**TOWN OF DAVIDSON
DESIGN REVIEW BOARD
Town Hall Board Room at 216 S Main St, Davidson, NC 28036**

January 17, 2018

Agenda Title: Cotton Mill

DAVIDSON MILL EXTENSION IMPROVEMENTS
(Name of Project)

8 COVERED PARKING PLAN
SCALE: 1/8" = 1'-0"

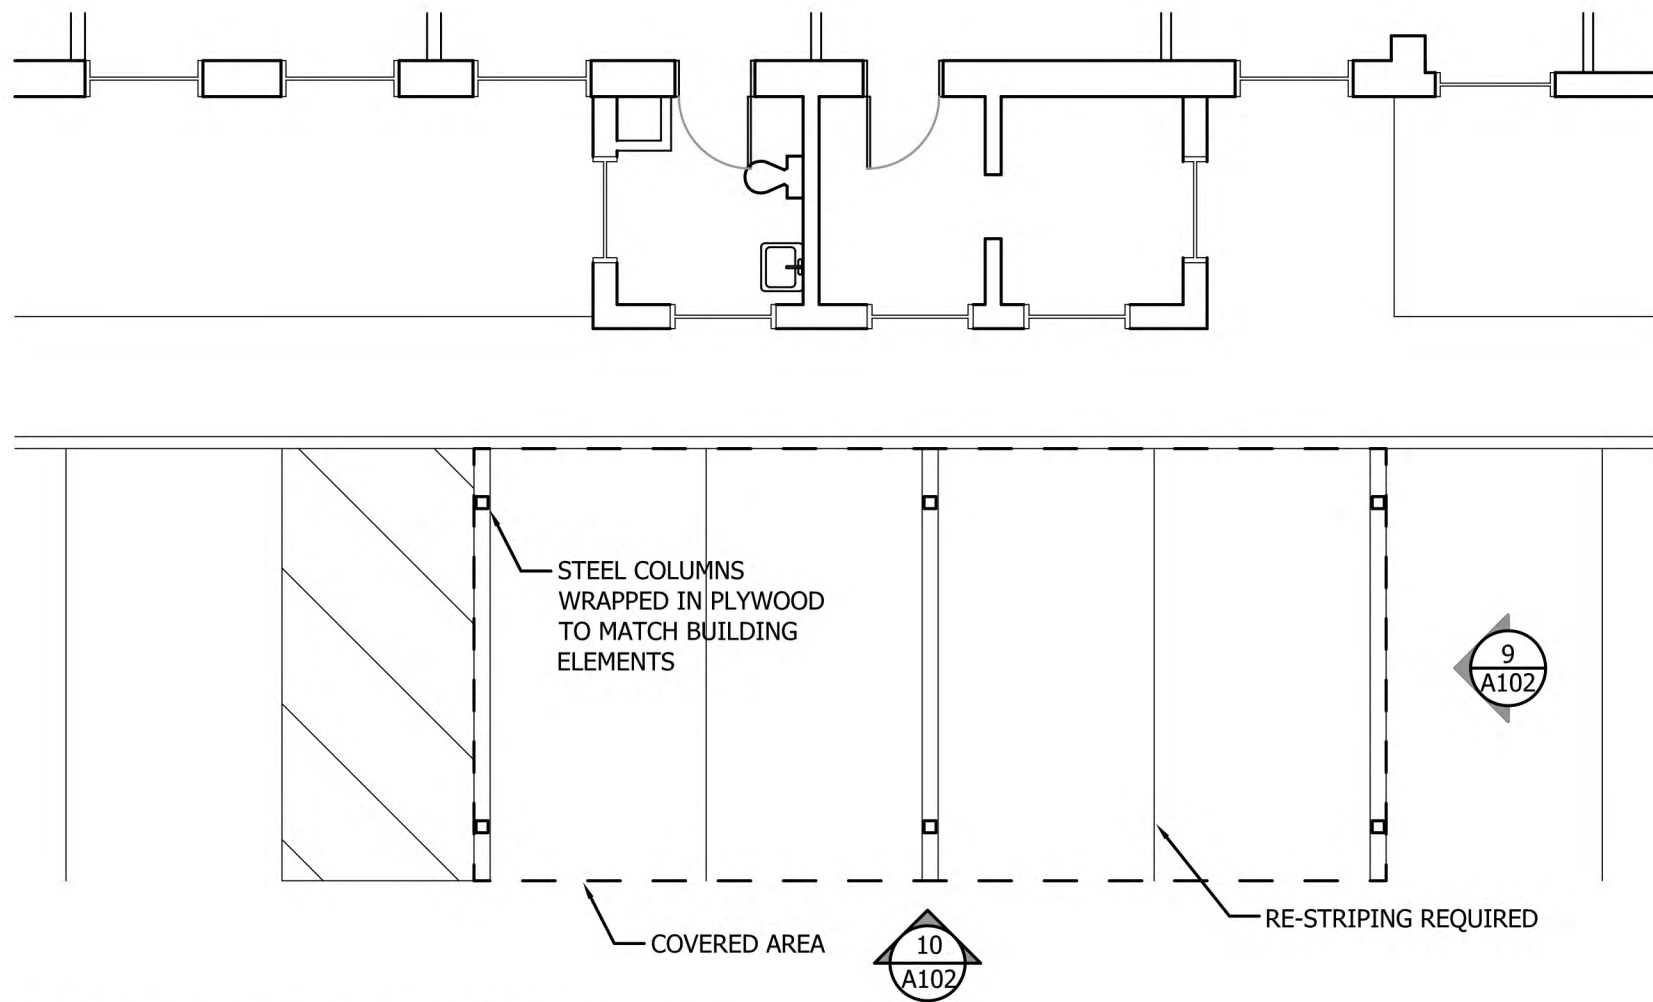
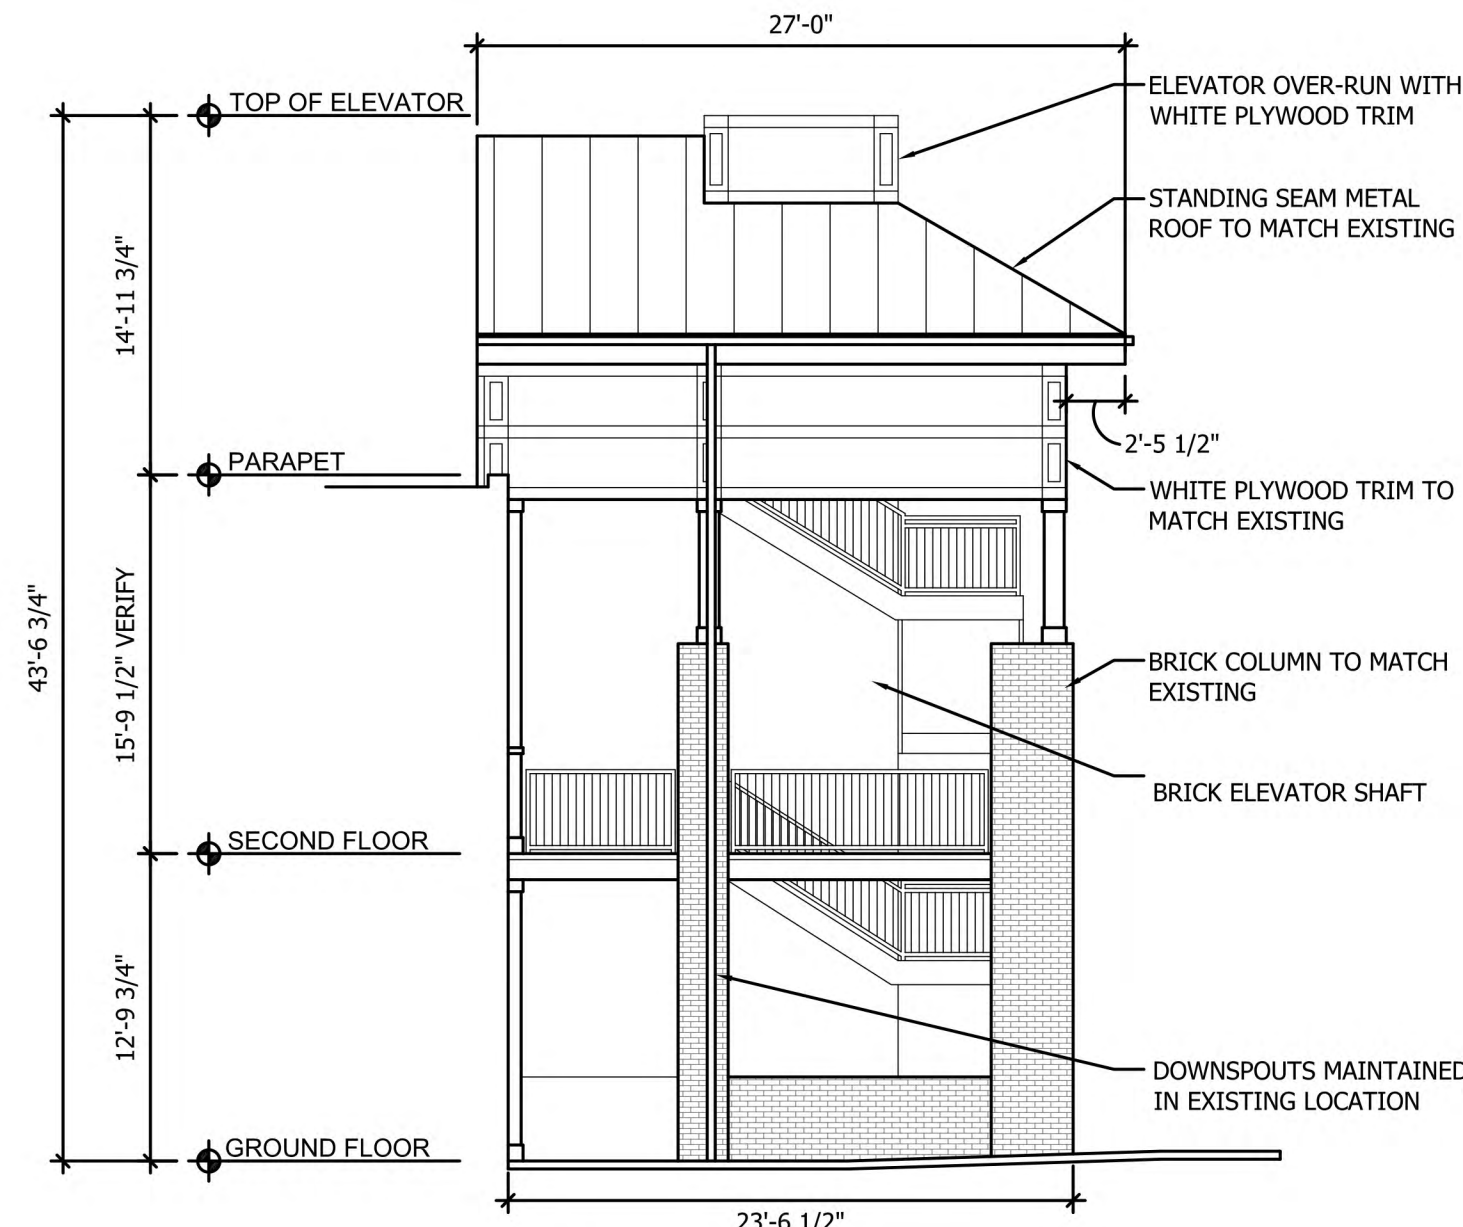
- Too much white board under roof.
- Covered Parking:
- Address proportion of columns and detail of how they attach to the underside of the beam (brackets).

6 ELEVATION - PLAN SOUTH
SCALE: 1/8" = 1'-0"

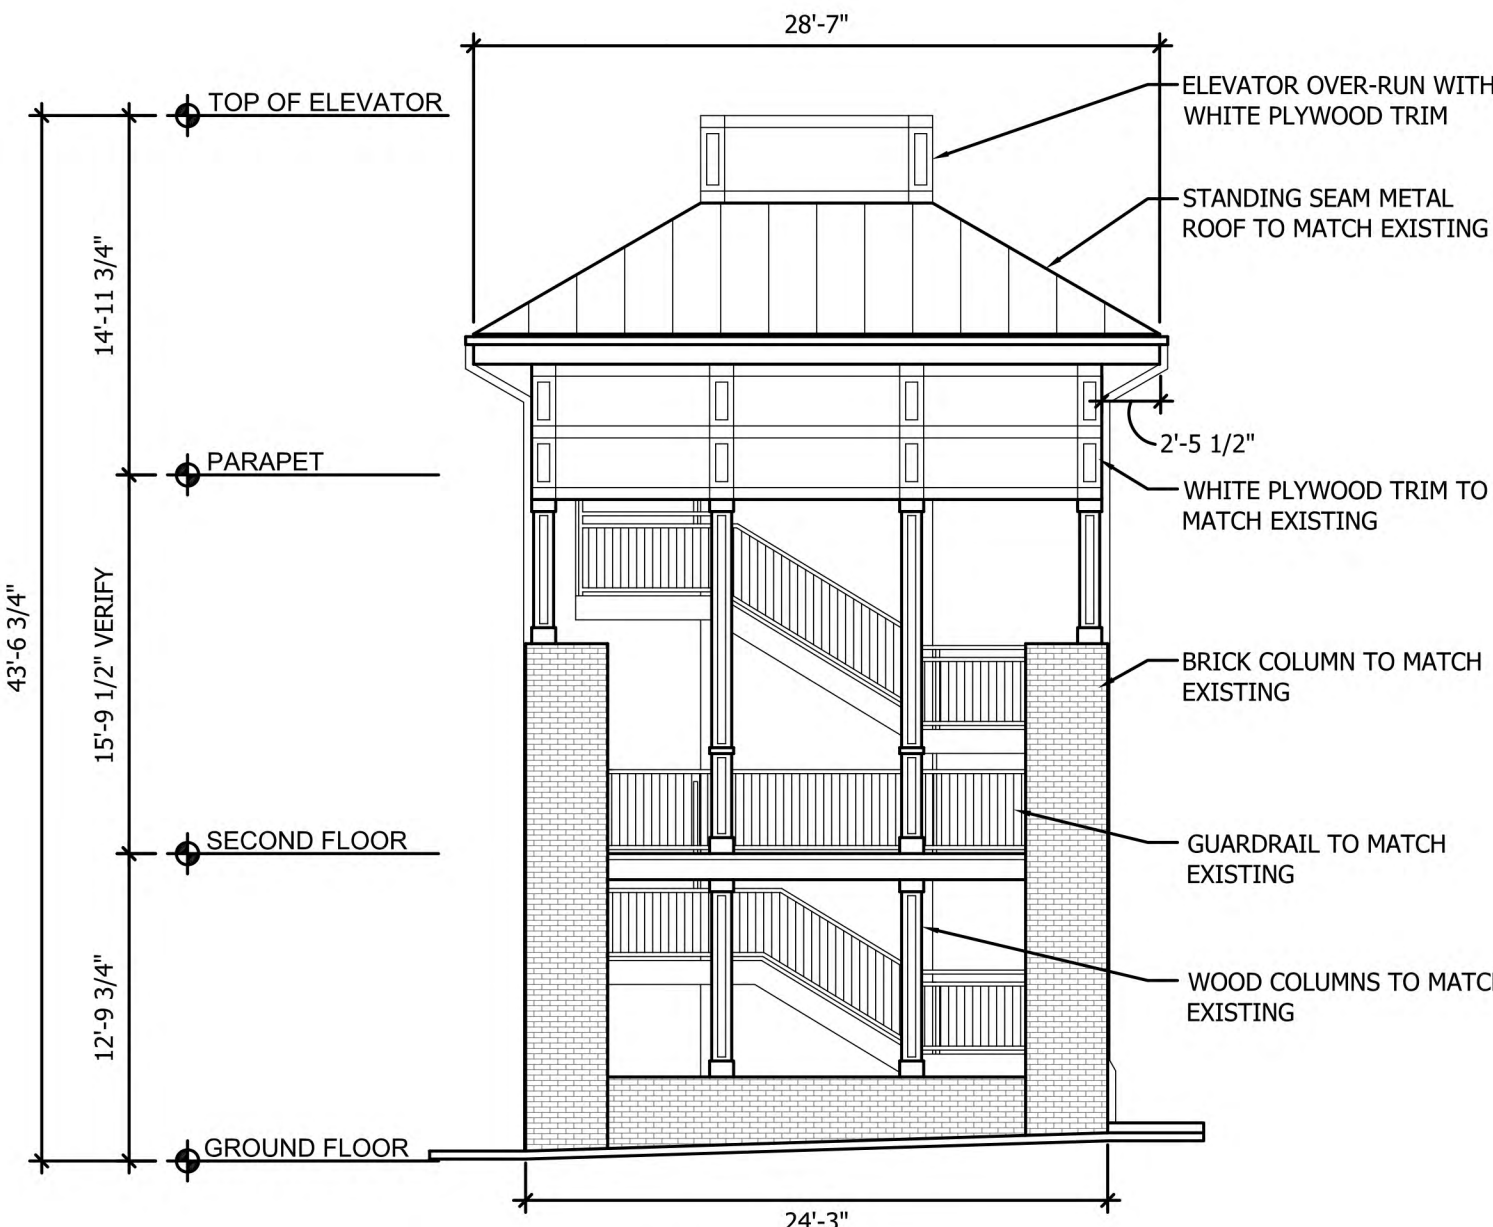
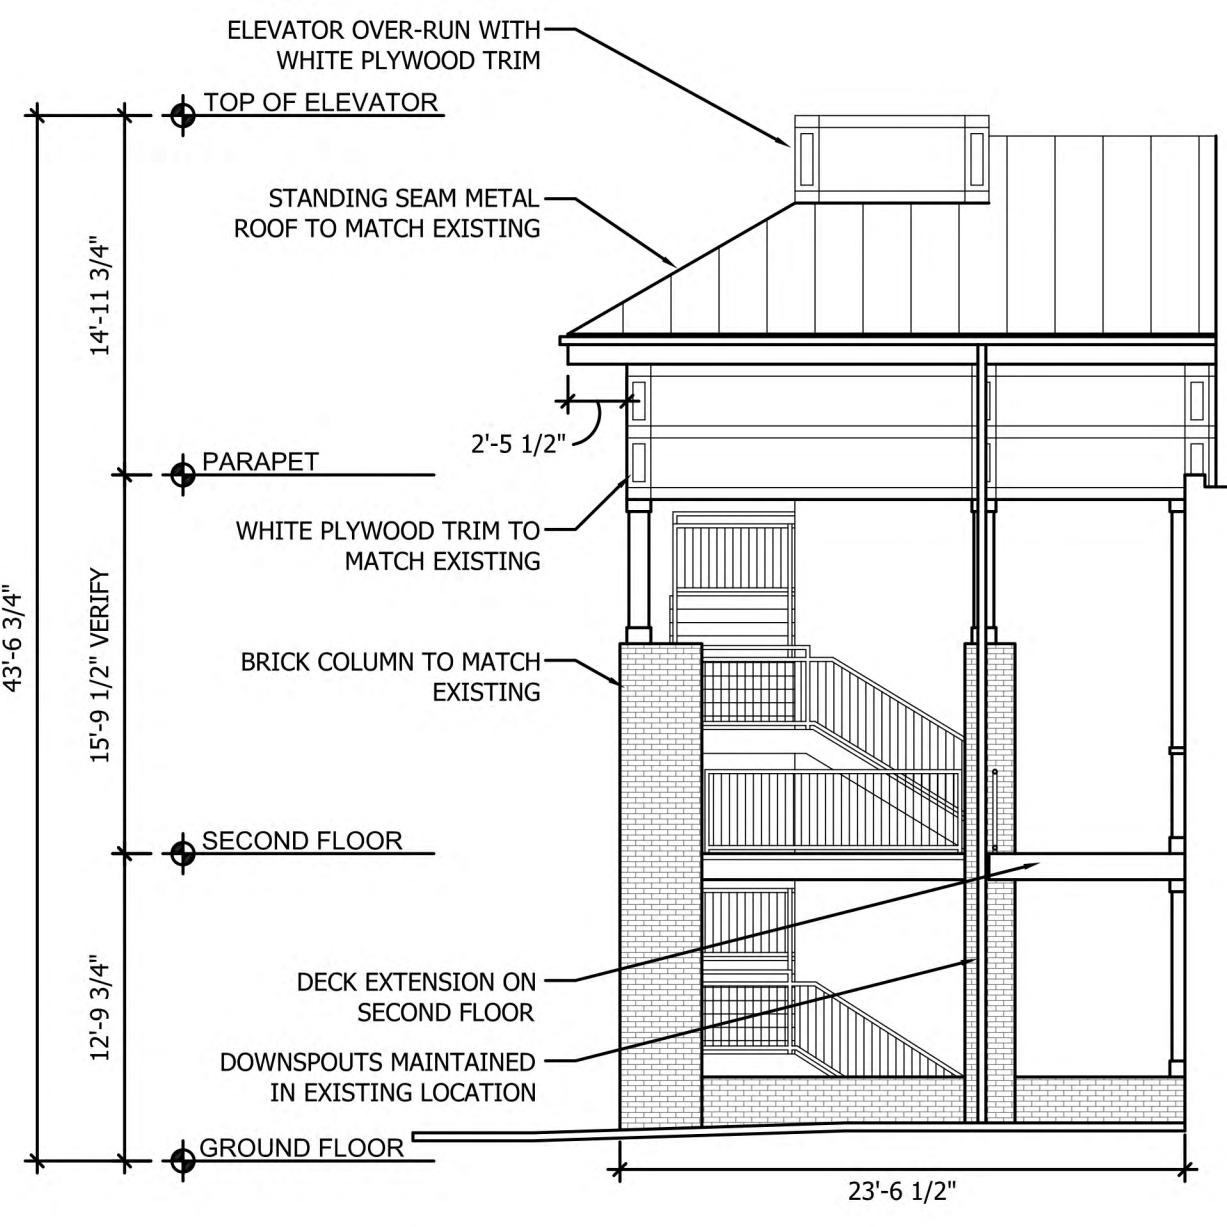
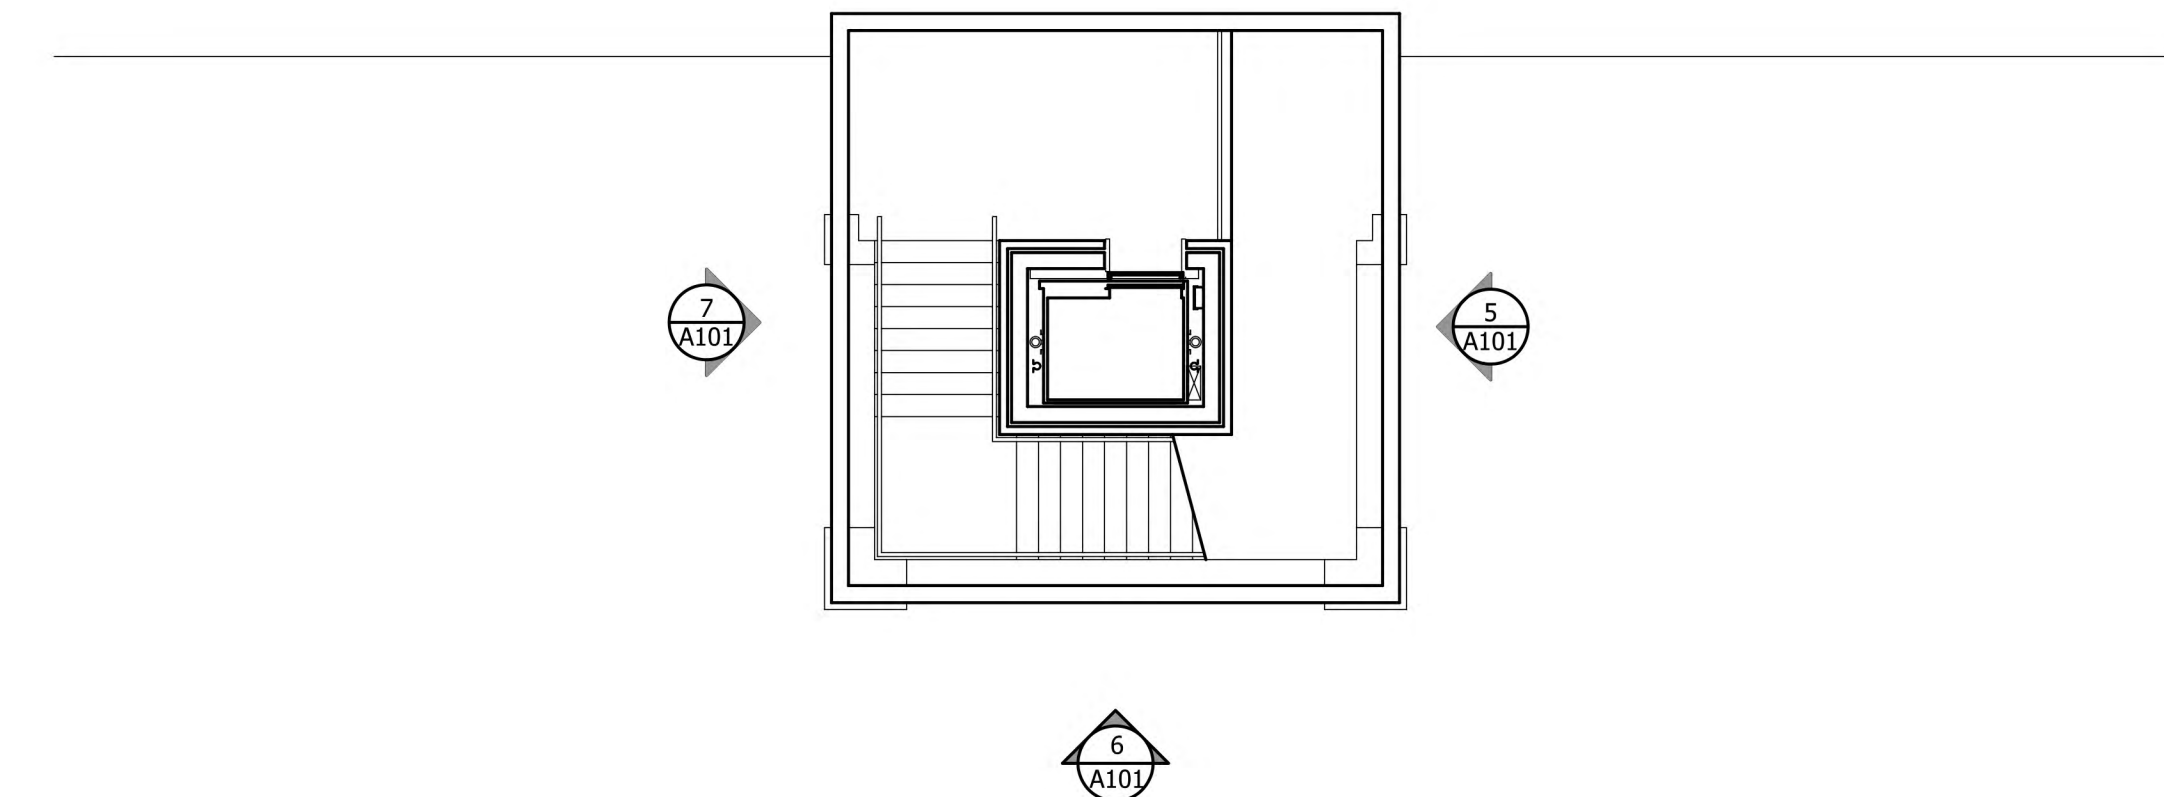
- Right Stair Pavilion:
 - How seen from side is still an issue. Try simple pyramid.
 - Wood columns seem skinny in proportion to the height (void). If columns get wider, may also need deeper floor depth to stay proportional.
